OUR TOWN HALL
MANCHESTER CITY COUNCIL

AIR RAID PRECAUTION CENTRE:
Further clarification and justification
August 2020
OTH-PUR-XX-XX-RPT-A-0133

Figure 2 The proposed plant layout and services with the existing columns shown (see appendix B for full page)

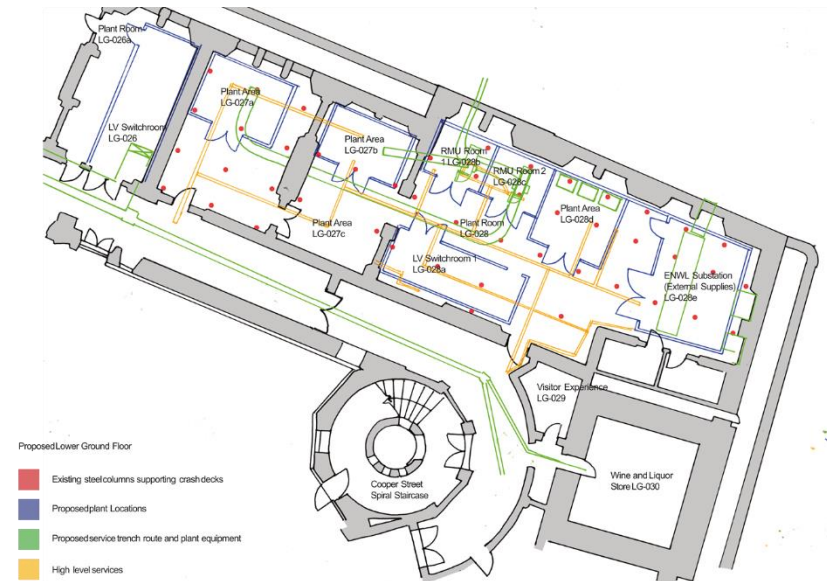
LG028 as demonstrated by the proposed plant room layout will leave no opportunity to retain the existing crash deck and ARP equipment. The majority of the open space will be subdivided into individual plant rooms, the floor of the space will be replaced and will have a series of trenches and drainage runs and high levels services will run across much of the space meaning it is not possible to retain the existing installation. The corridors that will be formed between the plantrooms will also need to be kept as a route free for access and maintenance for Vital and ENWL to move equipment in and out via the courtyard (see figure 2 and appendix B).
